## A82 Tarbet to Invernarnan upgrade project – alternative proposals

## **Helensburgh and District Access Trust's concerns about the proposals**

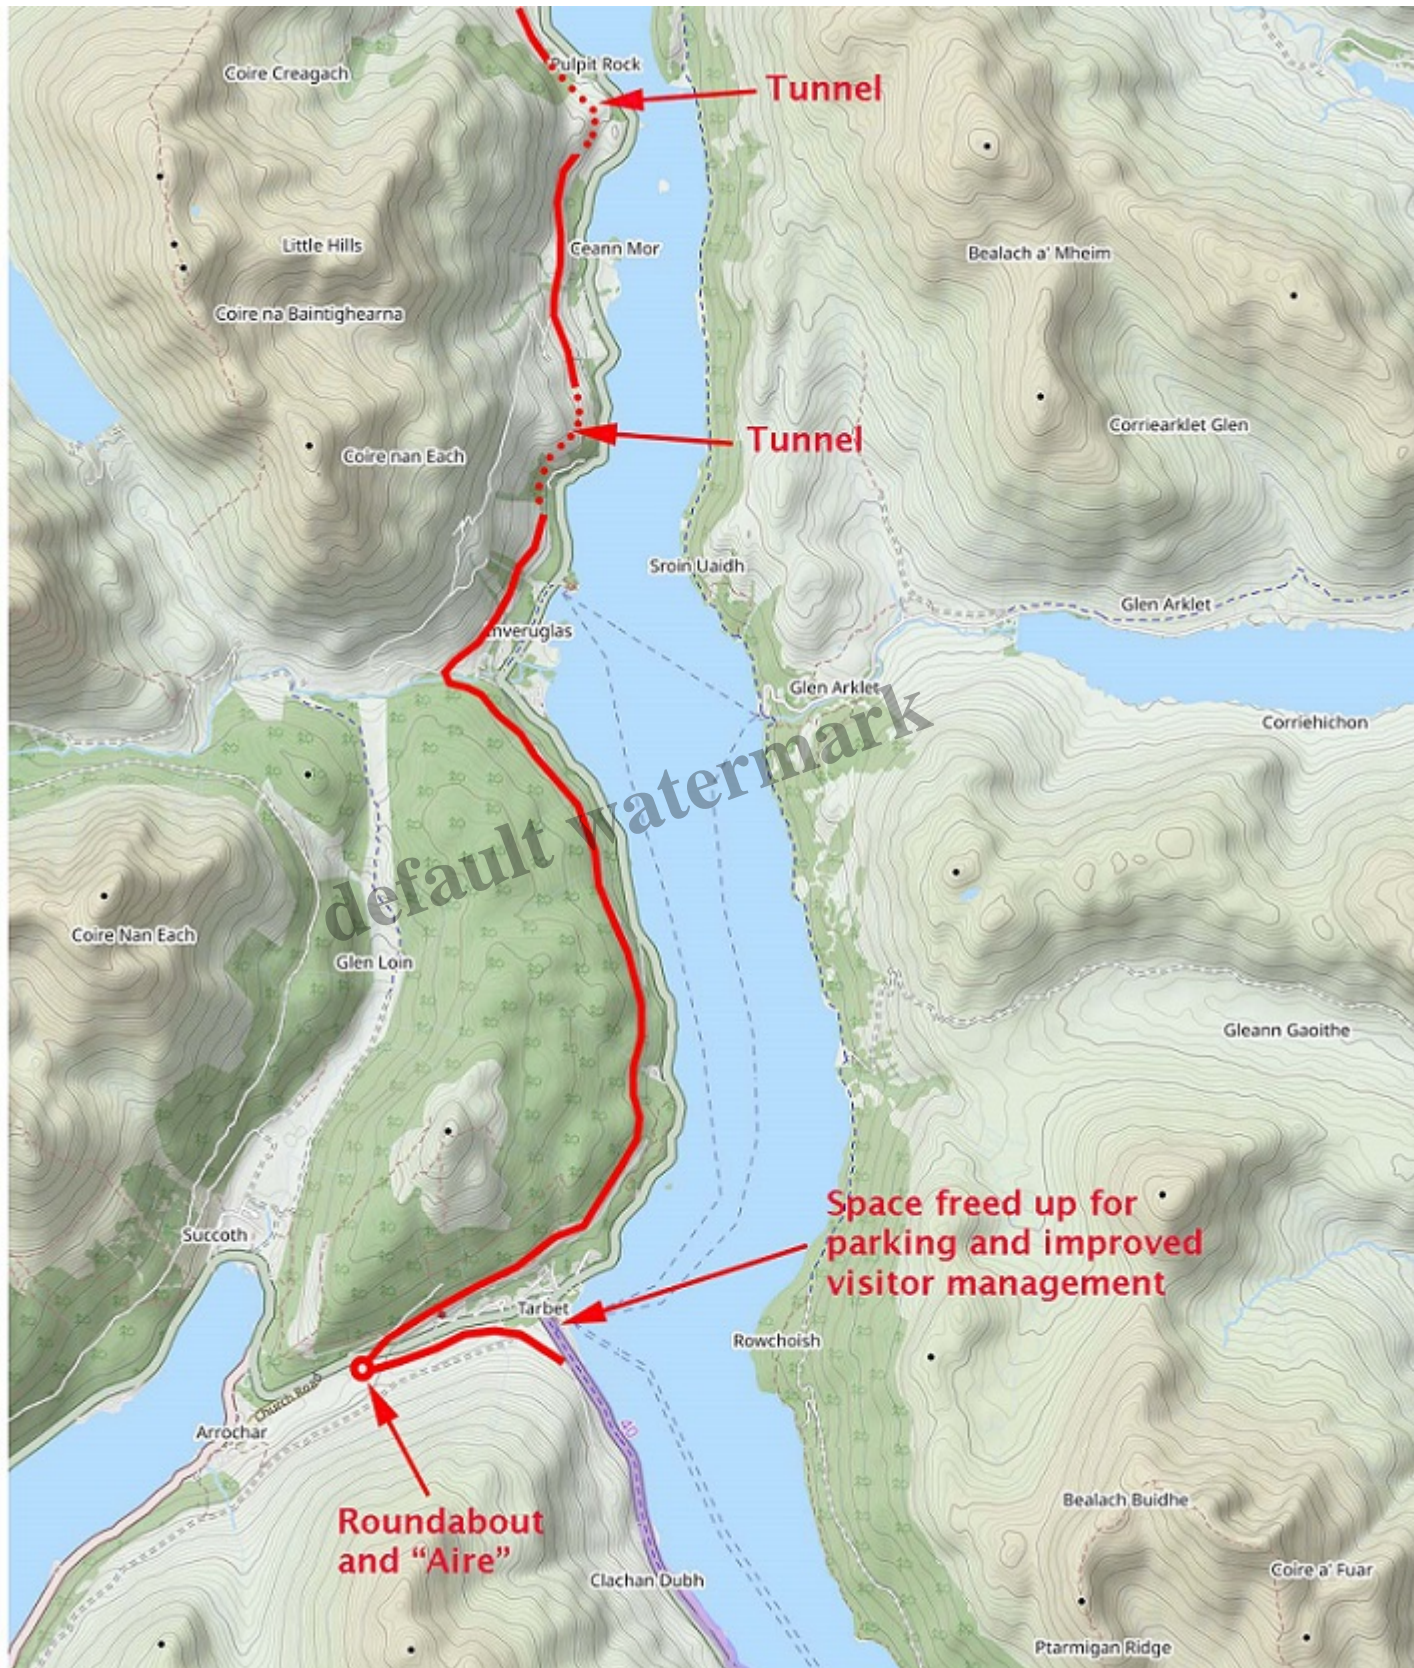
A better solution would have been to pull the road back from the water and where rock spurs exist, put it through a tunnel rather than having open cuttings backed by rock walls which reflect sound out over the water. Of course the presence of the West Highland railway line makes such a solution difficult, never mind the damage which would be done to the oakwoods. The route should therefore be above the railway line where the existing land use is dominated either by commercial conifer woodland or

poor quality rough grazing, both of which are severely degraded habitats of limited ecological value. Tunnels would be required at rock spurs or where slopes are particularly steep as they are above Creag a Phuirt and Pulpit Rock where some very steep and craggy ground is clothed in a substantial area of ancient birch/oak woodland.
